**METROPOLITAN GOVERNMENT OF NASHVILLE AND DAVIDSON COUNTY**

**STAFF RECOMMENDATION**  
**105 Lindsley Park Drive**  
**April 17, 2013**

**Application:** Demolition-contributing building and New construction-infill  
**District:** Lockeland Springs-East End Neighborhood Conservation Zoning Overlay  
**Council District:** 06  
**Map and Parcel Number:** 08309046400  
**Applicant:** Zach Provonchee  
**Project Lead:** Sean Alexander, sean.alexander@nashville.gov

**1** first floor plan  
 3/16" 0 2' 4' 8'

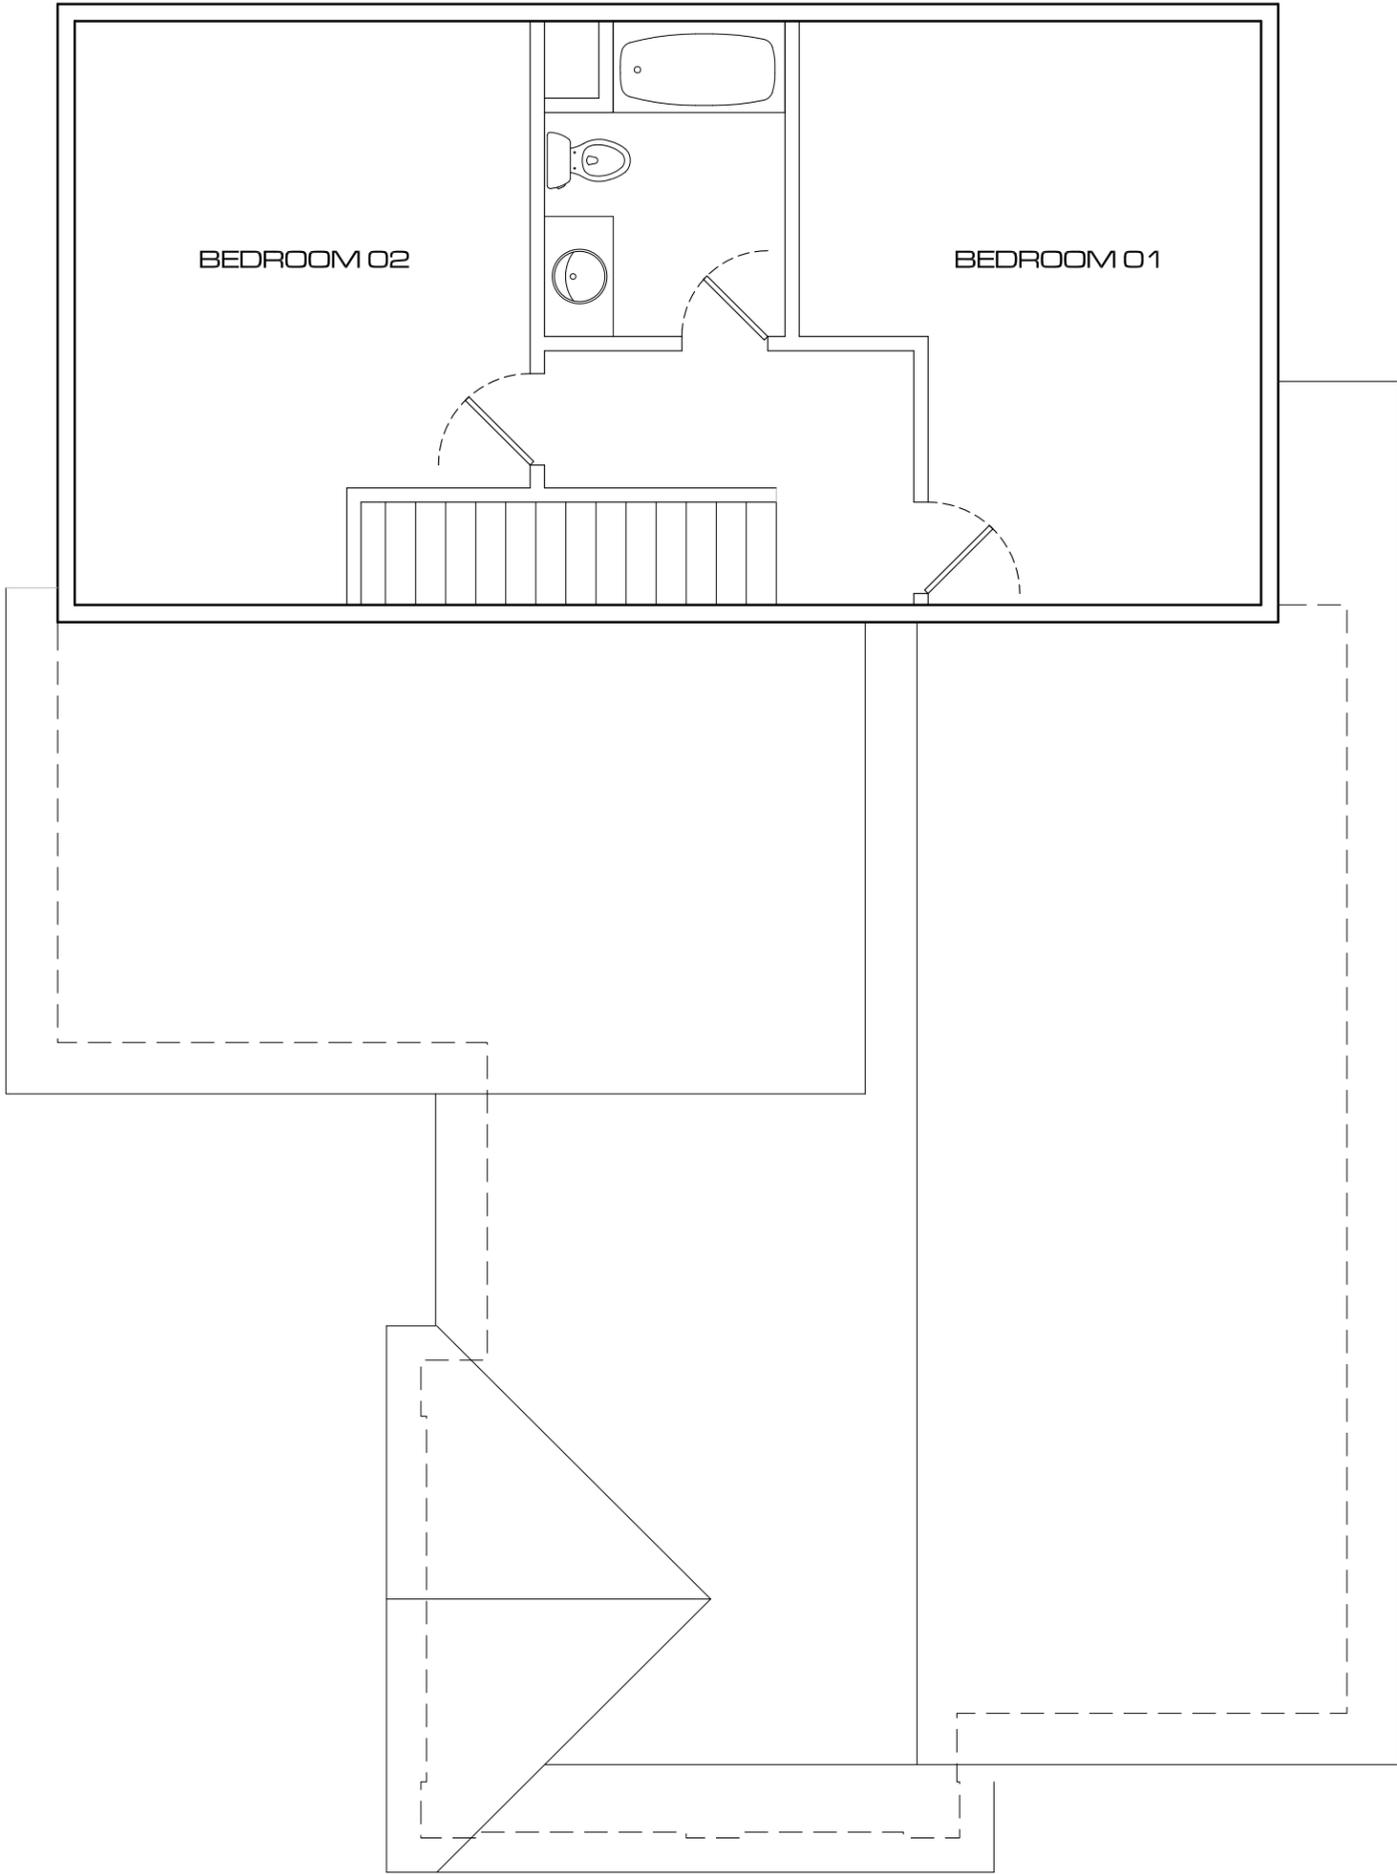
The side addition portion of the addition will begin behind the midpoint of the building, twenty-one feet (21') back from the front wall. The addition will project twelve-feet, six inches (12'-6") to the left, increasing the width of the house by 50%. The eave height of the addition will match the eave height of the existing house, with a low-pitched shed roof tying into the side slope of the existing roof. This roof will be partially obscured by the side gable of the existing porch, and will not impact the primary existing ridge. The foundation height will match that of the existing house. Considering the unique lot conditions described above, staff finds the height and scale of the proposed side addition to meet guidelines II.B.1 and II.B.2.

1 proposed south elevation  
 3/16" 0 2 4 8

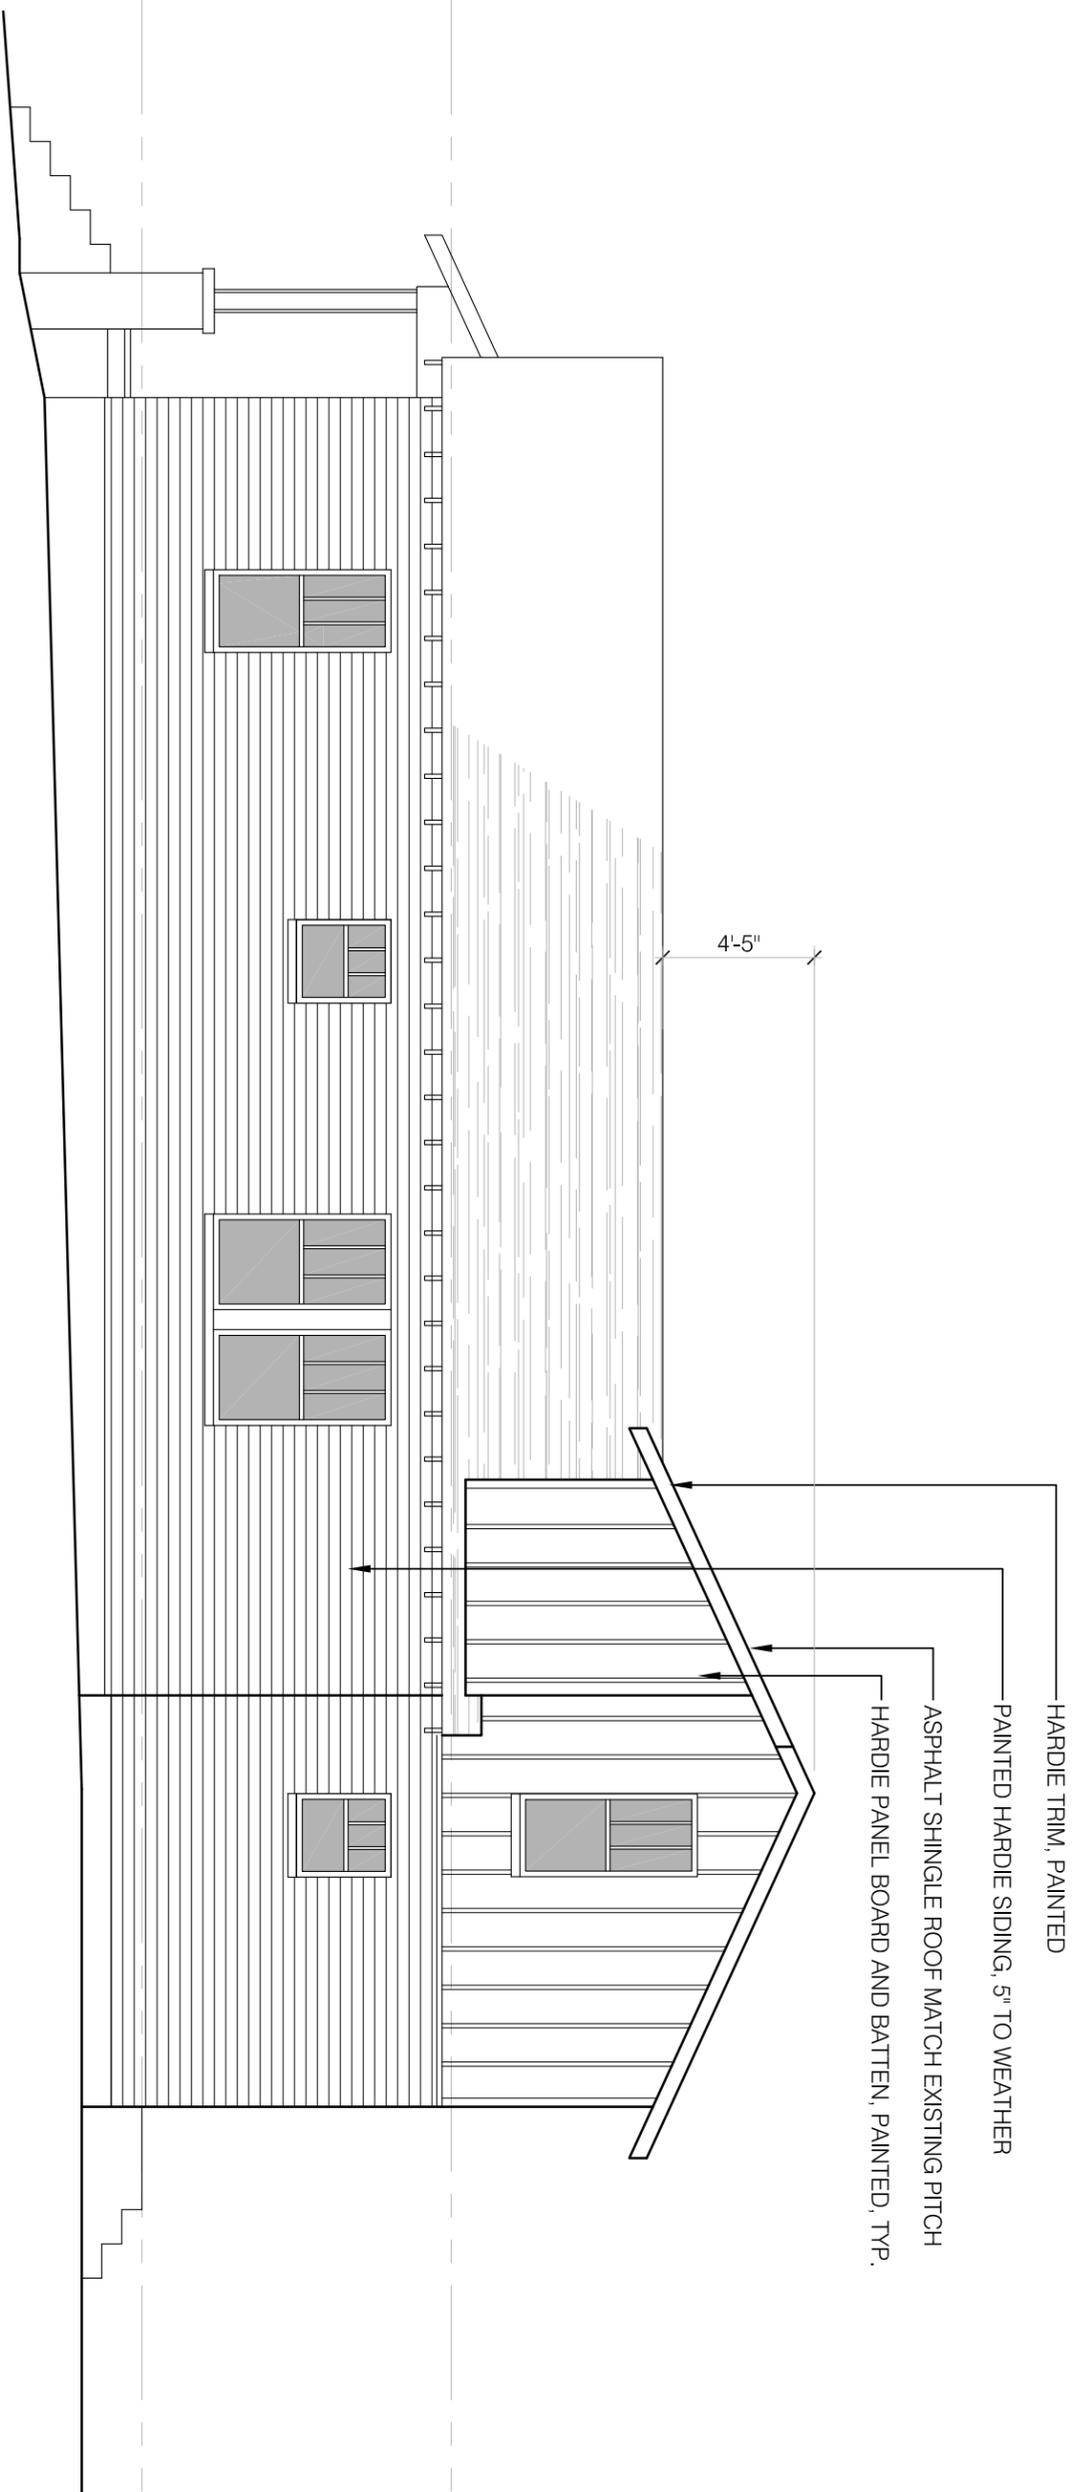
The rear addition will set in from the side of the existing house by two feet (2') on the right side, and extend across the lot to align with the wall of the side addition on the left. The roof of the addition, a side-facing gable, will be four feet, five inches (4'-5") taller than the existing roof. The peak of this roof will be forty-two feet (42') behind the front wall of the house. The eave of the rear addition would be five feet, six inches (5'-6") above the existing eaves. The foundation height will match that of the existing house. Because of the unique lot conditions described above, staff finds the height of the addition to be appropriate, but would recommend that the eave height be brought down eighteen inches (18") as a condition of approval. This will reduce the amount of wall-space viewed from the right-of-way, which is roughly ten feet (10') lower in elevation than the front of the house.

The walls of the addition will have a visible impact on the roof of the original building starting six feet (6') up from the rear of the house. Typically, this configuration would not be appropriate; however, since the primary roof would not accommodate a ridge raise and the ceiling height is too low to benefit from side dormers, staff finds the proposed side addition to be appropriate. Setting the addition in two feet (2') from the right side on the house also helps maintain the original form. With a condition that the leading eave be lowered eighteen inches (18"), staff finds the rear addition to meet guidelines II.B.1 and II.B.2.

1. The second story eave height be lowered eighteen inches (18");
2. Four inch (4") window casings and cornerboards be added;
3. The window and foundation material, and the roof color be approved by Staff;
4. Any new or relocated appurtenances be approved by Staff;
5. That material information and major proportions be labeled on the drawings.
